The following are my comments on the draft of the “City of Carpinteria Coastal Vulnerability and Adaptation Project” document (hereafter, “Draft”). I appreciate the opportunity to review the document and give feedback during this public comment period; I hope this feedback can help the final document be a more effective tool in helping Carpinteria deal with sea level rise (SLR).

John Callender
4466 Mesa Lane
Carpinteria, CA 93013

- Table 22: Projected Sea-Level Rise (in feet) for Santa Barbara (OPC 2018, p. 66)
- Table 23: Probability that Sea-Level Rise will meet or exceed a particular height (in feet) in Santa Barbara (OPC 2018, p. 67)

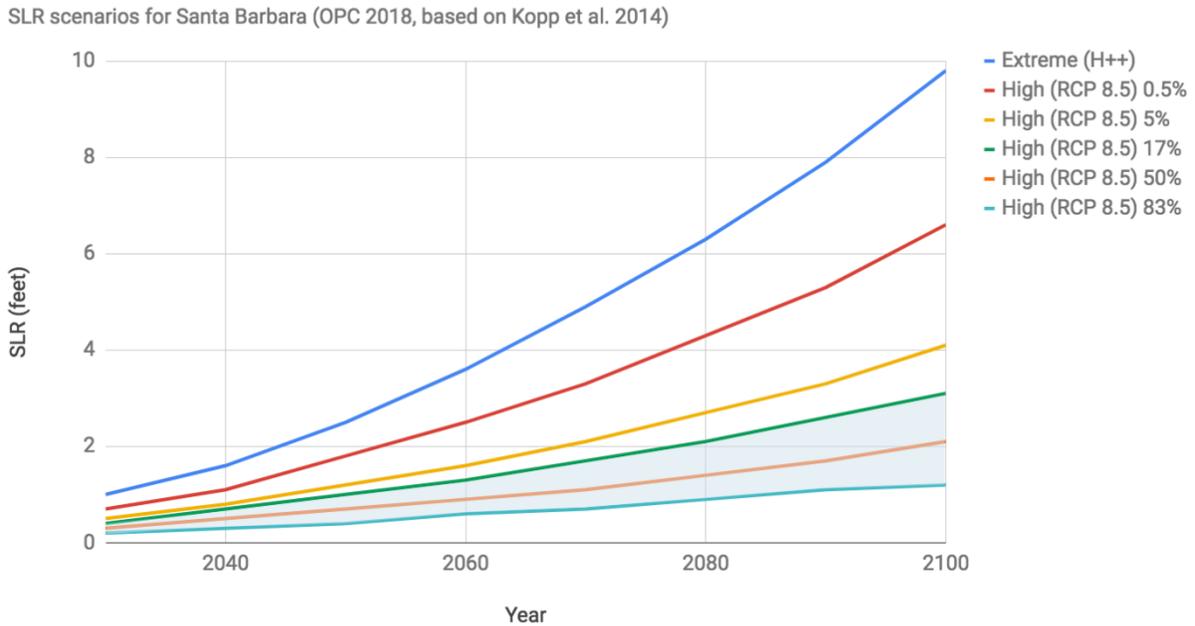
I also think the Draft should include the following two tables from OPC 2018, both of which would be more useful and easier for decision makers to understand than Table 24 (which the Draft does include, but which, as I mentioned above, is hard to interpret due to its use of mm/year rather than cumulative feet of SLR):

SLR scenarios for Santa Barbara (OPC 2018, based on Kopp et al. 2014)

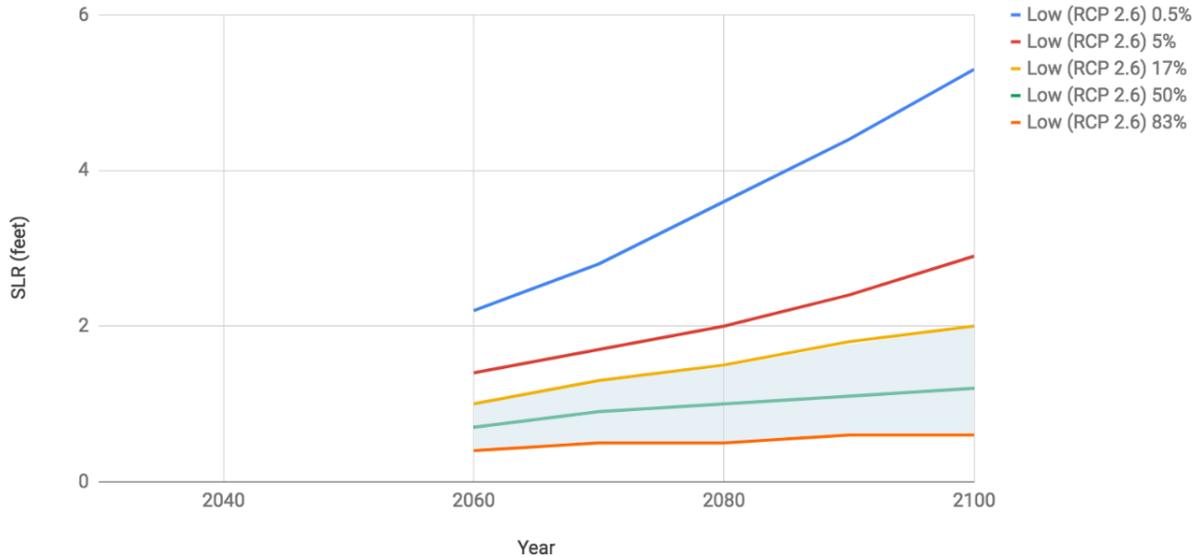
Regardless, I think it is important that such graphs be included in the city's Draft. It would not be difficult to create the small number of graphs we would need based on the OPC 2018 data for Santa Barbara. Below are a few example graphs I created by entering the data from Table 22 in OPC 2018 into a Google Docs

The Draft should include at least a graph such as that first one (for the RCP 8.5 and H++ scenarios), and possibly the second one as well (for the RCP 2.6 scenario) as part of an expanded discussion of SLR scenarios and scenario probabilities.
